## **AGENDA**

489 McHenry Avenue, Echo Spur – Plat Amendment - PL-12-01629  
Public hearing and possible recommendation to City Council

# Planning Commission Staff Report

**Subject:** LMC Amendment Discussion  
**Author:** Francisco Astorga, Planner  
**Date:** July 31, 2013  
**Type of Item:** Work session – Legislative, LMC Amendments HRM District

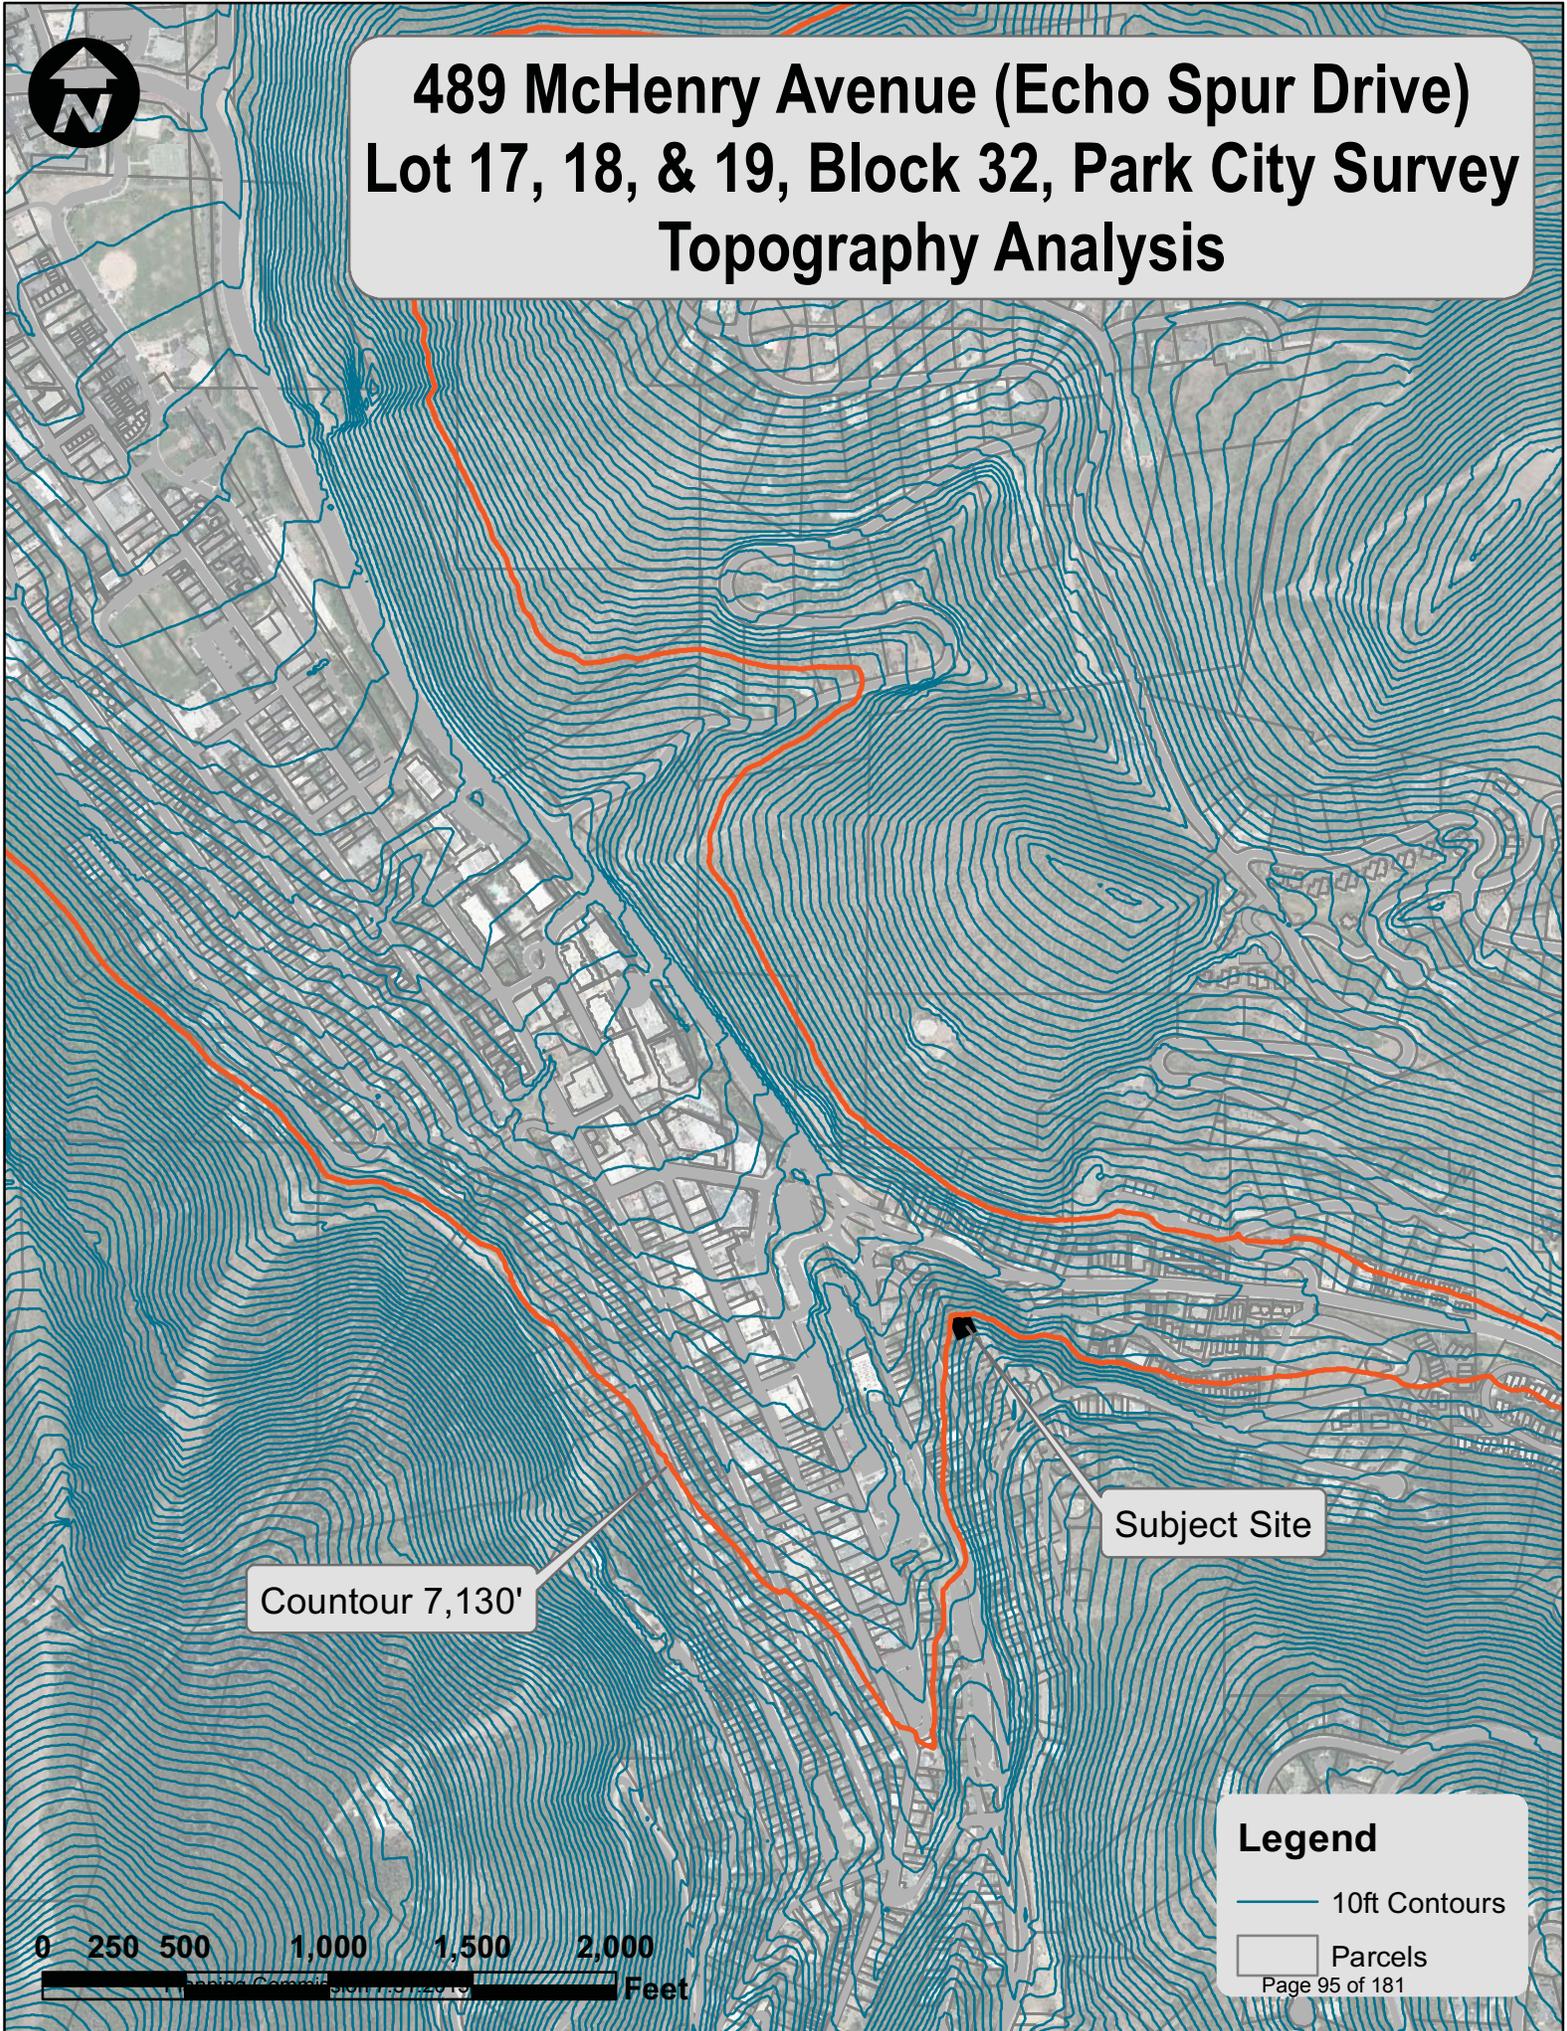
Staff interprets that this development on the Aerie (Masonic Hill) was indeed built on this ridgeline. Furthermore, this development does not meet the current ridgeline protection ordinance as it breaks the skyline from these four (4) vantage points. This development was built in the early 1980's. The ridge line protection ordinance was adopted in 2001. The Sensitive Lands Overlay (SLO) ordinance, further restricting development on ridge lines, was adopted in 2000 and amended in 2005 and 2007.

Unlike the four (4) photographs shown herein with the Aerie development, the proposed plat amendment combining Lot 17, 18, & 19, Block 58, Park City Survey, consisting of a plat amendment lot consolidation from three (3) into one (1) does not break the skyline when viewed from any of the adopted vantage points, including the across canyon view shown on Exhibit K of the June 26, 2013 staff report supported by Exhibit A of this report. This subject site is also not within the SLO area.

**Does the Planning Commission concur with this assessment of ridgeline development?**

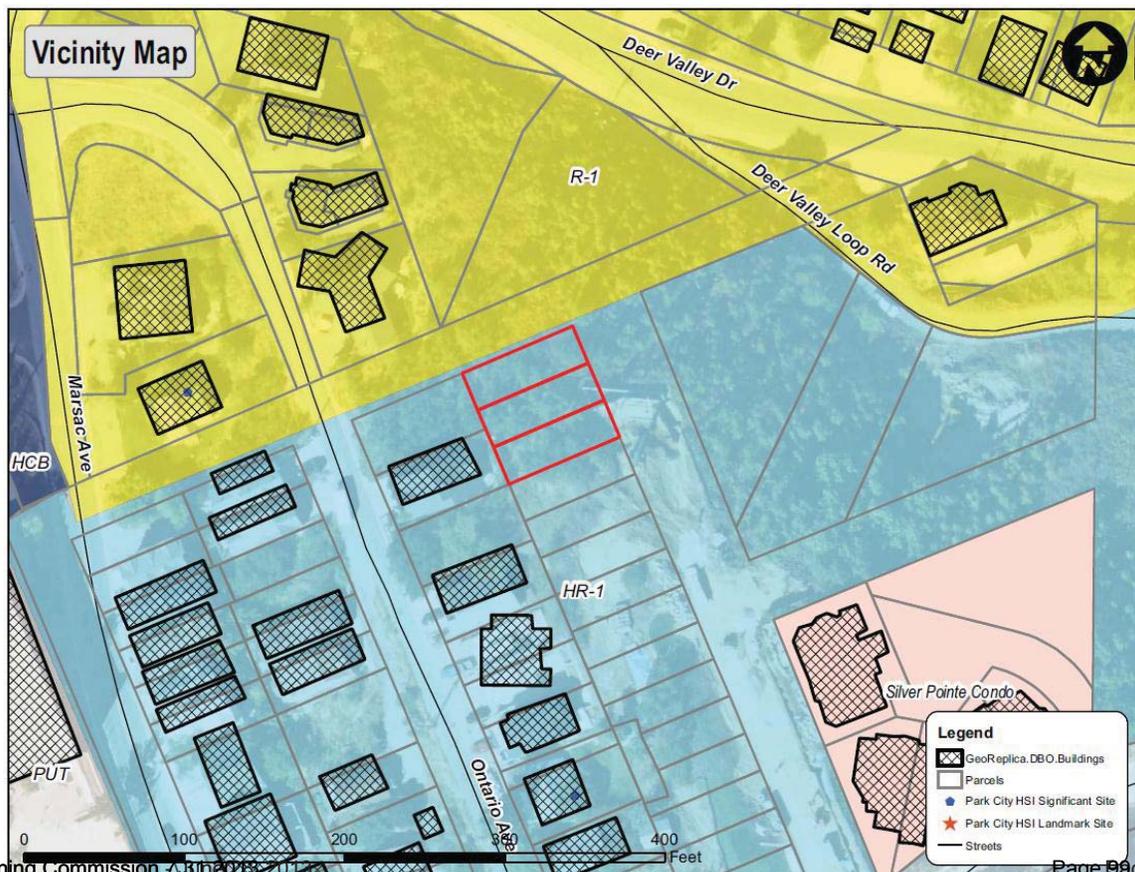
The proposed plat amendment creates one (1) lot of record from Lot 17, 18, 19, Block 58 of the Park City Survey, three (3) legal lots of record. The minimum lot area for a single family dwelling is 1,875 square feet. The minimum lot area for a duplex is 3,750 square feet. The proposed lot area is 5,625 square feet. A duplex is a conditional use that requires Planning Commission review and approval. The minimum lot width is twenty five feet (25'). The proposed lot width is seventy five feet (75').

The applicant has indicated that he would like to build a single family dwelling. Staff has identified the following development standards of the HR-1 District as summarized below:
